Planning App Ref:	PL/2026/01361
Service Ref:	Drainage
Date:	13/07/2026

PROPOSAL

The Bike School, London Road, Devizes, SN10 2JG

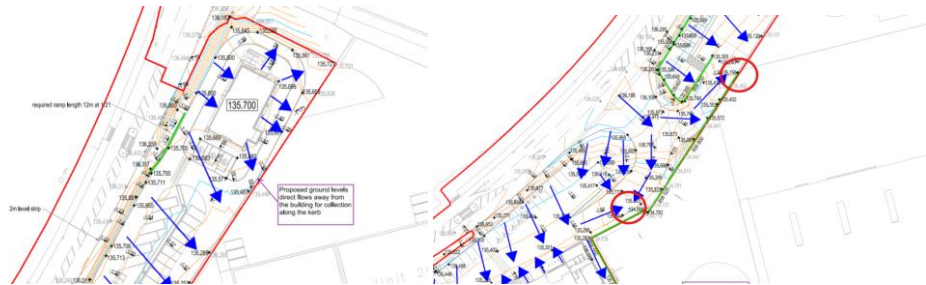
The comparison table of pre-development runoff rates identifies a significant discrepancy between the calculated greenfield runoff rates, with the FEH method estimating a 1 in 100-year runoff rate of 6.2 l/s compared to 136.4 l/s using the Modified Rational Method (MRM). No explanation has been provided to justify the considerable difference between these estimates.

7. Evidence that the proposed drainage design provides a sufficient level of water treatment.
8. Tabulated comparison of pre-development greenfield rates, existing brownfield rates, and proposed post-development discharge rates. For more information refer to Wiltshire Council's betterment policy update which can be found [here](#).

The comparison table shall clearly present the Greenfield, Brownfield, and proposed controlled discharge rates for each relevant rainfall event (including the 1 in 1 year and 1 in 100 years plus climate change events, where applicable), to enable a clear comparison between existing and proposed site runoff rates.

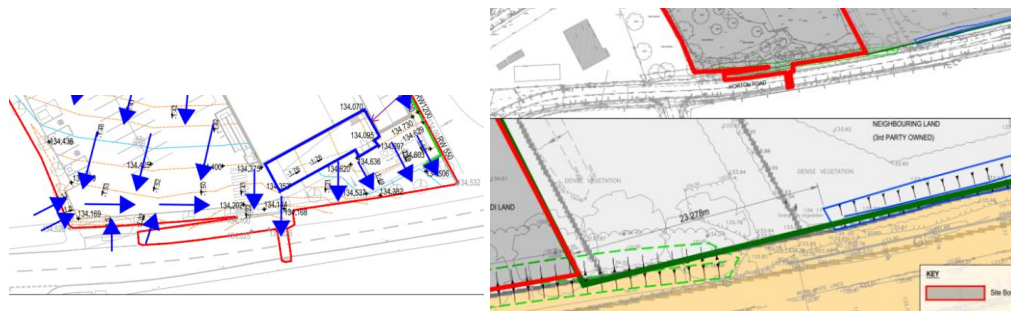
10. It is noted that the applicant has provided an exceedance flow routing plan; however, further details are required in order to demonstrate adherence to National Standard 3. The submitted plan indicates that the proposed drive-through building may be at risk of flooding during exceedance events, and low points along the north-western site boundary could result in ponding and increase flood risk to adjacent third-party land.

Furthermore, it is unclear how exceedance flows will be conveyed in a controlled manner to the receiving ditch adjacent to Horton Road. As the ditch begins further east of the site, exceedance flows may travel along Horton Road before being intercepted. The applicant shall demonstrate that exceedance flows can be safely managed without increasing flood risk to Horton Road or surrounding land.

Where surface water ponding is proposed within designated hardstanding areas as part of the exceedance flow strategy, these areas shall be clearly identified on the relevant drawings using appropriate hatching. Details of the maximum predicted depth of standing water shall be provided.
